**Minutes of the North Carolina Building Code Council**  
**June 12, 2018**  
**Raleigh, NC**

**Part A Administrative Items**

**FIGURE AM109.1(1)  
NO LATERAL BRACING**

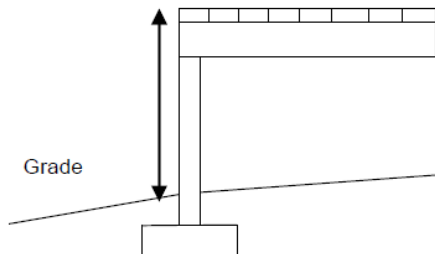
When the deck floor height is less than 4 feet (1219 mm) above finished grade as shown in Figure AM109.1(1) and the deck is attached to the structure in accordance with Section AM104, lateral bracing is not required. Lateral bracing is not required for freestanding decks with a deck floor height 30 inches (762 mm) or less above finished grade.

Less than 4' (decking to grade) and attached to structure no bracing required

**FIGURE AM109.1(2)**  
**KNEE BRACING**

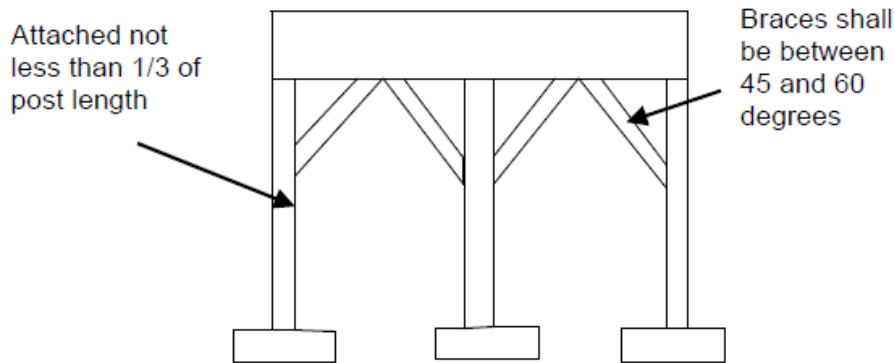
4x4 wood knee braces are permitted to be provided on each column in both directions for freestanding decks or parallel to the structure at the exterior column line for attached decks per Figure AM109.1(2). The knee braces shall attach to each post at a point not less than 1/3 of the post length from the top of the post, and the braces shall be angled between 45 degrees (0.79 rad) and 60 degrees (1.05 rad) from the horizontal. Knee braces shall be bolted fastened to the post and the girder/double band in accordance with one 5/8 inch (16 mm) hot dip galvanized bolt with nut and washer at both ends of the brace of the methods shown in Table AM109.1; as shown in Figure AM109.1(2).

Freestanding decks requiring bracing shall be installed in both directions off each post

Decks attached to structure require diagonal bracing only at outside girder line parallel with structure

**Residential Super Committee: Motion to accept. Second. Accepted.**  
**Building Code Council: Motion. Second. Granted.**

**FIGURE R4603.6(b)  
TOP MOUNTED GIRDER**

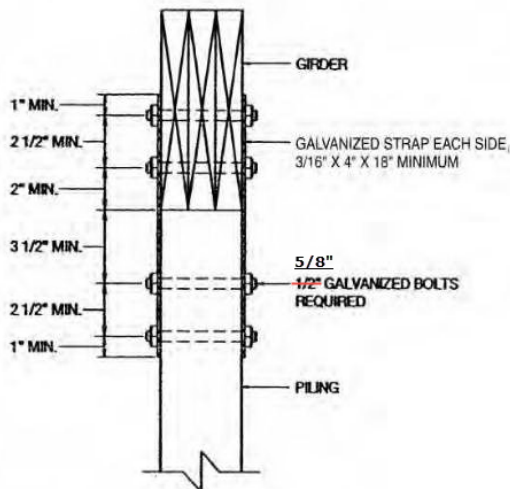
Beams and girders shall fully bear on pilings and butt joints shall occur over pilings. If Ssills, beams or girders are shall be attached to the piling a minimum of two 5/8-inch (16 mm) galvanized steel bolts per beam member shall be through bolted using either bolts or screws at each piling connection in accordance with Table R4603.6 and Figure R45603.6 (a). When the piling is notched so that the cross-section is reduced below 50 percent or the girder is top bearing, sills, beams or girders shall be attached using 3/16 × 4 × 18-inch (5 × 102 × 467 mm) hot dip galvanized straps, one each side, bolted with two 5/8 inch (15.9 mm) galvanized through bolts fastened top and bottom in accordance with either bolts or screws in accordance with Table R4603.6 and Figure R4603.6(b) and Figure R45603.6(c). Where butt joints occur over the piling and screws are used, there shall be two straps on each side of the piling, having a minimum size of 3/16 by 2 by 18 inches (5 × 51 × 467 mm), with four self-drilling screws as described in each end.

**R4603.6.2 Bracing of Pilings.** Bracing of pile foundations is required where the clear height from ground to sill, beam or girder exceeds 10 feet (3048 mm) or the dwelling is more than one story above piles. A line of X-bracing is defined as a row of piles with X-bracing provided in at least two bays. A line of X-bracing shall be provided at all exterior pile lines. Where the perimeter lines of X-bracing exceed 40 feet (12 192 mm), an additional line of X-bracing shall be provided near the center of the building. See Figure R4603.6(e). X-bracing shall be with 2 × 10s through bolted with two 3/4-inch (19.1 mm) bolts at each end. The code official is permitted to accept alternate bracing designs if they bear the seal of a registered design professional. Revise Figures as follows:

**FIGURE R4603.6(c)  
PILING NOTCHED MORE THAN 50%**

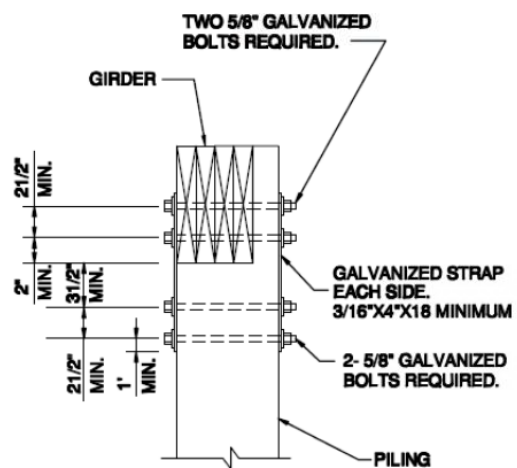
1. Where piling is notched over 50%, use strap as required in Section 4603.6. Install the specified number of bolts or screws in each end of the strap.

**Figure 410.2 Exception Closet Storage Space Exception**

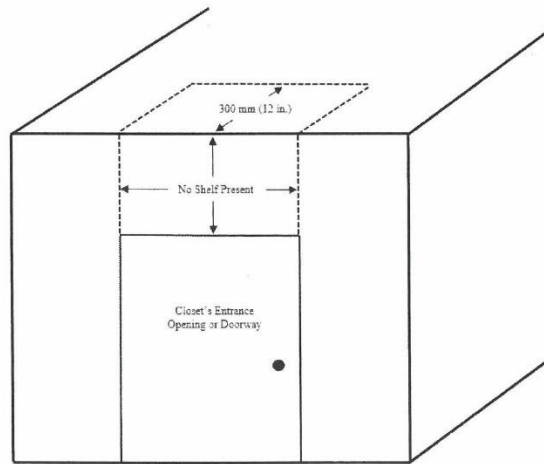
**Closet Storage Space.** The volume bounded by the sides and back closet walls and planes extending from the closet floor vertically to a height of 1.8 m (6 ft) or to the highest clothes-hanging rod and parallel to the walls at a horizontal distance of 600 mm (24 in.) from the sides and back of the closet walls, respectively, and continuing vertically to the closet ceiling parallel to the walls at a horizontal distance of 300 mm (12 in.) or the width of the shelf, whichever is greater; for a closet that permits access to both sides of a hanging rod, this space includes the volume below the highest rod extending 300 mm (12 in.) on either

side of the rod on a plane horizontal to the floor extending the entire length of the rod. See Figure 410.2.

Where a shelf is not present in the area of wall above the closet's entrance opening or doorway extending from the top of such opening or doorway vertically to the ceiling, including the area of ceiling extending perpendicular from the area of wall directly above the closet's entrance opening or doorway to a horizontal distance of 300 mm (12 in.) shall not be defined as closet storage space. See Figure 410.2
